La Jolla Shores Planned District Advisory Board (LJSPDAB) APPLICANT PROJECT INFORMATION FORM

- Project Tracking System (PTS) Number/Accela "PRJ" Number and Project Name (only submitted projects to the Development Services Department can be heard as action items):
PRJ-1085883

- Address and APN(s):
8303 LA JOLLA SHORES DRIVE, LA JOLLA, CA 92037
APN(s): 346-250-0800, 346-250-0900, 346-250-1000
- Project contact name, phone, e-mail:
ANDY FOTSCH - WILL AND FOTSCH ARCHITECTS
858-224-2486
PERMITS@WILLANDFOTSCH.COM

- Project description:
 - **SITE DEVELOPMENT/COASTAL DEVELOPMENT/NEIGHBORHOOD DEVELOPMENT PLANS**
 - 1 CONSOLIDATED LOT SPLIT INTO 6 INDIVIDUAL LOTS
 - EACH LOT TO CONSIST OF 1 SINGLE FAMILY DWELLING

A003
LOT 3 - SITE PLAN

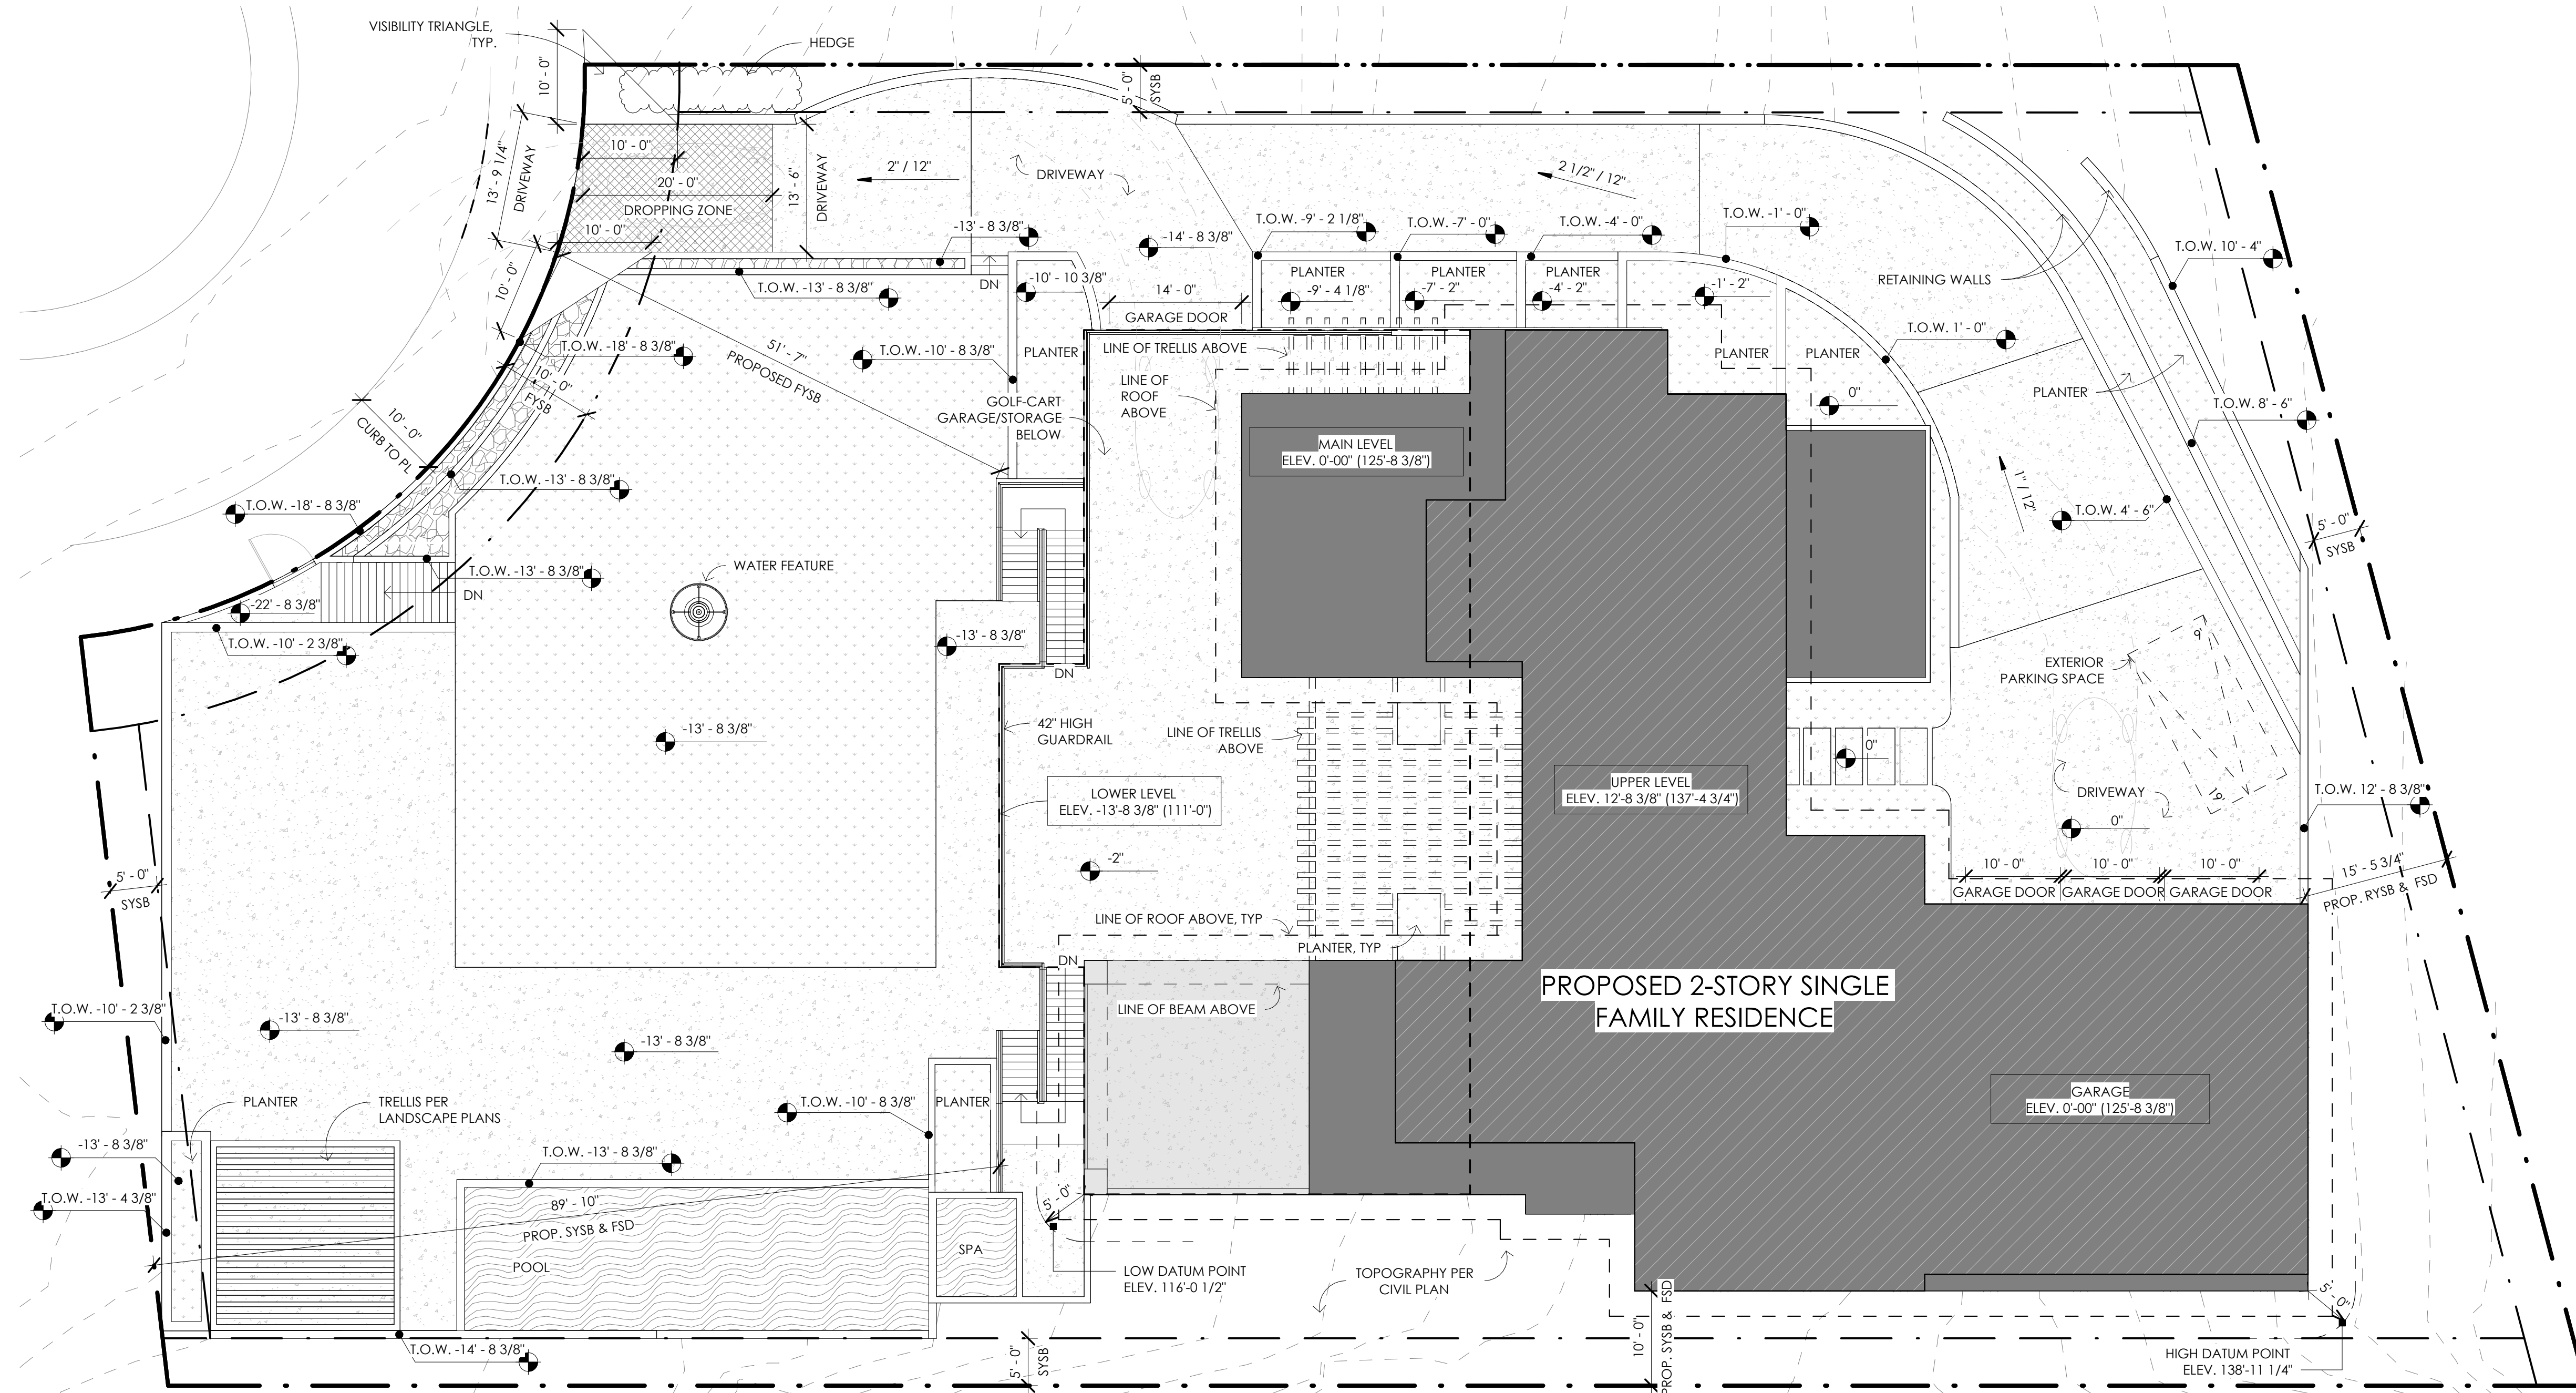
Per Issue #103 in the previous review cycle, please dimension the drive aisle width along the curb towards the basketball court for Lot 3 on Sheet A003. Please also dimension the drive aisle width for Lot 4 as it appears be wider than the maximum of 25 feet allowed and appears to vary in width beyond the driveway curb cut opening on Sheet A004. Please dimension the drive aisle width at the narrowest and widest points per SDMC Section 142.0560(j)(4). (2nd Request)

A204

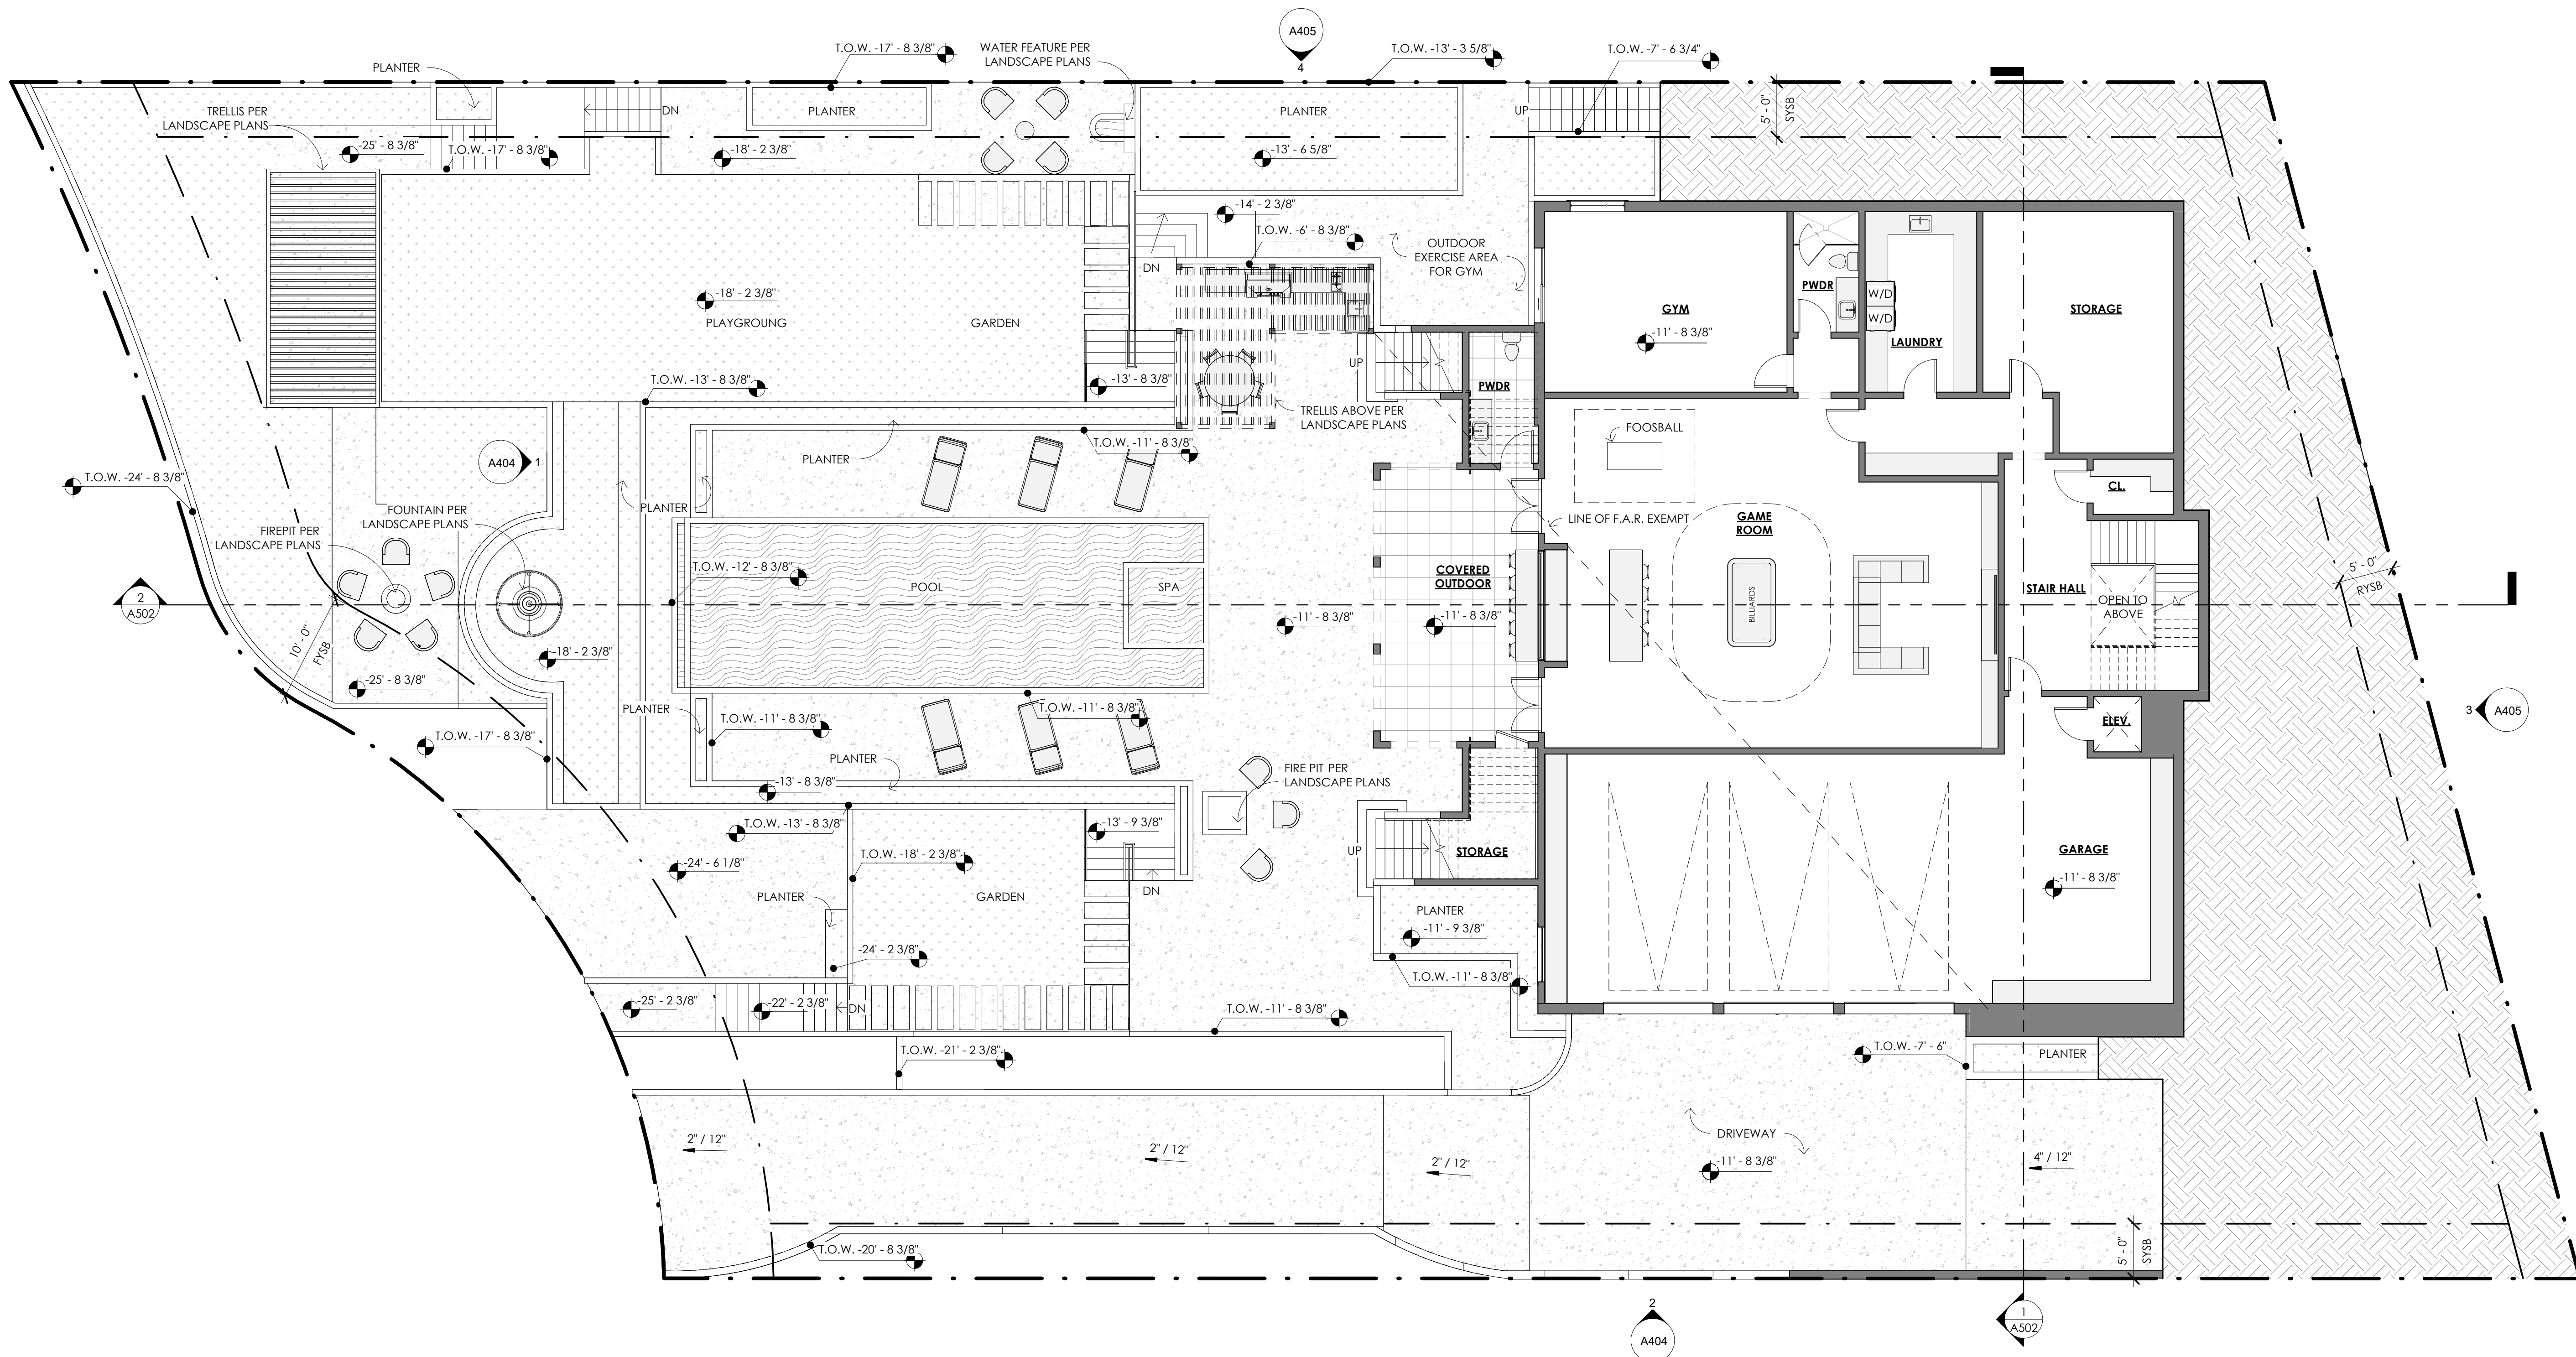
Sheet A204 shows 1 surface parking space and 4 garage spaces for Lot 2. It appears that vehicles would not be able to maneuver in and out of the proposed garage parking spaces with the proposed surface parking space. Please remove the proposed surface parking space from the plans and revise the parking count.

A208

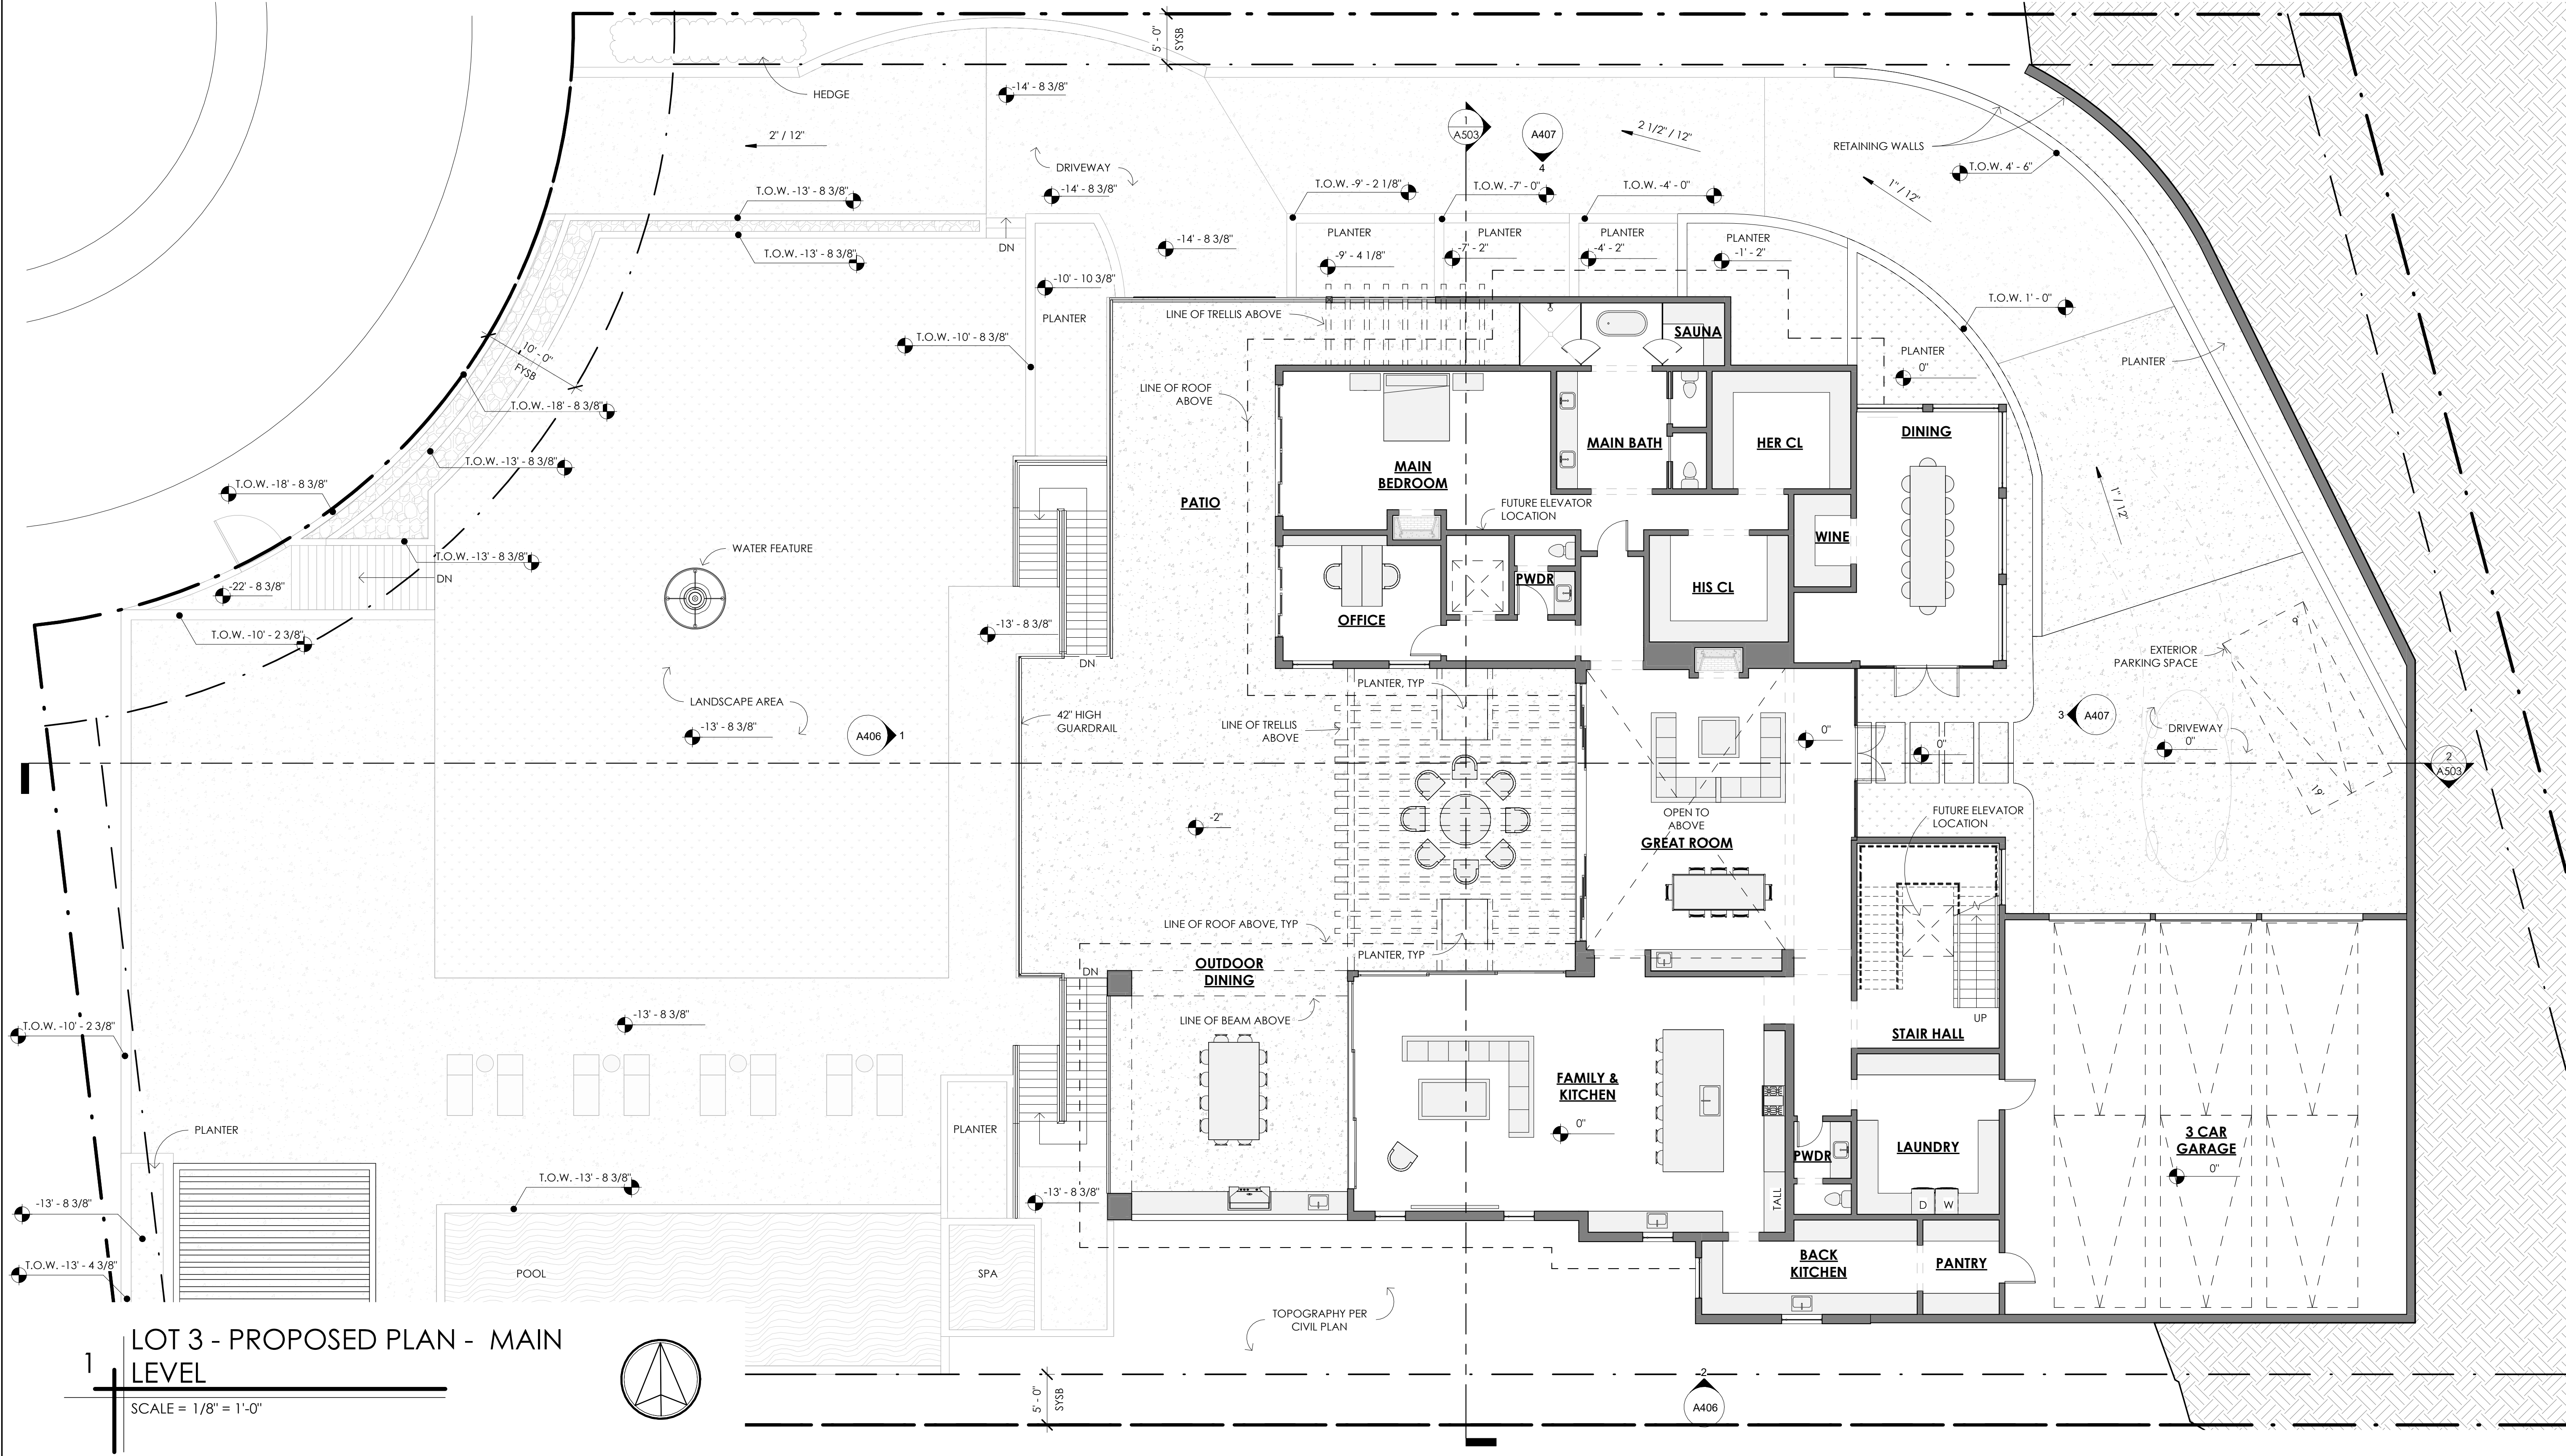
Per the applicant's response to Issues #103 and #201, the drive aisles for Lots 3 and 4 have been dimensioned on Sheets A000, A208, A209, and A214. However, the drive aisle widths are still not dimensioned for these lots. Please revise and dimension the drive aisle width for Lots 3 and 4 per SDMC Section 142.0521(e). Please note that a drive aisle is different from a driveway; a drive aisle is located within a project site. (3rd Request)

Sheet A208 shows 2 garage spaces in tandem; please clarify whether the rest of the lower garage will be for storage or any other use. Sheet A209 shows 1 surface parking space and 6 garage spaces in tandem configuration. It appears that the surface parking space would obstruct the parking spaces on the east side of the garage. Please demonstrate that vehicles can adequately maneuver in and out of these spaces through a turning template or remove the surface parking space from the plans and revise the parking count.
